**HISTORIC PRESERVATION REVIEW BOARD  
STAFF REPORT AND RECOMMENDATION**

Property Address: <b>1235 4<sup>th</sup> Street NW</b>	<input type="checkbox"/> Agenda
Landmark/District: <b>Mount Vernon Square Historic District</b>	<input type="checkbox"/> Consent Calendar
ANC: <b>6C</b>	<input type="checkbox"/> Denial Calendar
	<input checked="" type="checkbox"/> Permit review
Meeting Date: <b>May 23, 2013</b>	<input checked="" type="checkbox"/> Revision
H.P.A. Number: <b>#12-317</b>	<input type="checkbox"/> New Construction
Staff Reviewer: <b>Brendan Meyer</b>	<input type="checkbox"/> Demolition
	<input type="checkbox"/> Subdivision

Owner, Sergei Mikhailov, seeks permit approval for a stair penthouse and roof deck revision to a previously approved new rowhouse in the Mount Vernon Square Historic District. Concept design plans were prepared by John Linam Jr., Architect, PLLC.

**Figure 1.** Proposed stair penthouse, 1213 4<sup>th</sup> Street NW

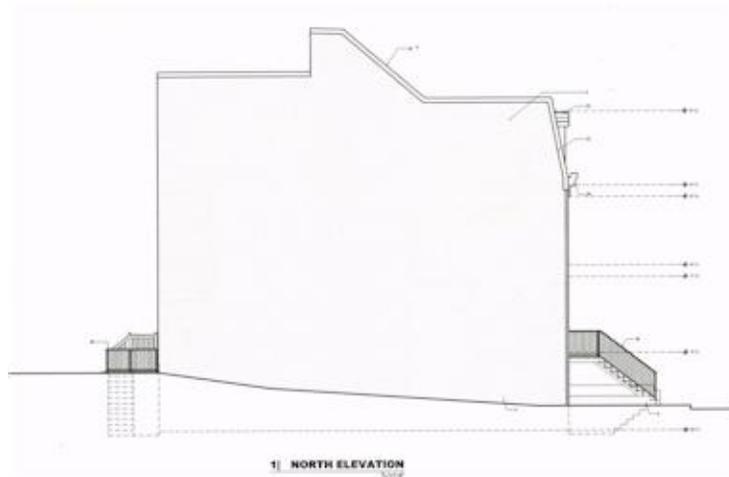
permit design calls for a 9 foot tall stair penthouse engaged with the north party wall and setback from the front roof ridge 12 feet. The north wall of the house would end the row.

The proposed location and size for the penthouse stair will result in a building profile uncharacteristic of the historic rowhouses of the Mount Vernon Square Historic District. It would be a comparatively large element on an otherwise modestly scaled rowhouse, purposefully designed in a traditional style to compatibly fit in with the existing streetscape. It would be clearly visible for a long distance from 4<sup>th</sup> Street, N Street, and likely Ridge Street. Development may occur in the vacant lot at 1251-1253 4<sup>th</sup> Street which might screen some of the penthouse stair, but when that development might occur and what shape it might take is uncertain.

The historic rowhouses of 4<sup>th</sup> Street which contribute to the character of the historic district are generally simple in ornament, size, massing and material. The original concept approval for 1235 4<sup>th</sup> Street included a mansard third floor unlike its historic neighbors, and in that the Board extended a fair amount of flexibility to the project because it is new construction rather than an existing historic rowhouse. The mansard form is common enough for the historic district to not be out of place or character on the street. However, adding a penthouse stair this large and starkly visible will alter the building profile into something else entirely that would be out of character anywhere on the row.

As this new construction project has not yet broken ground, an opportunity remains to design a roof deck with access from the rear façade or elsewhere on the roof plate that would solve the issue by avoiding a visible stair penthouse and incompatible roofline for the structure.

*The staff recommends that the Board advise the Mayor’s Agent that the proposed alteration for a substantially visible stair penthouse at 1235 4<sup>th</sup> Street NW is not consistent with the purposes of the preservation law, because it is not compatible with the character of the historic district.*
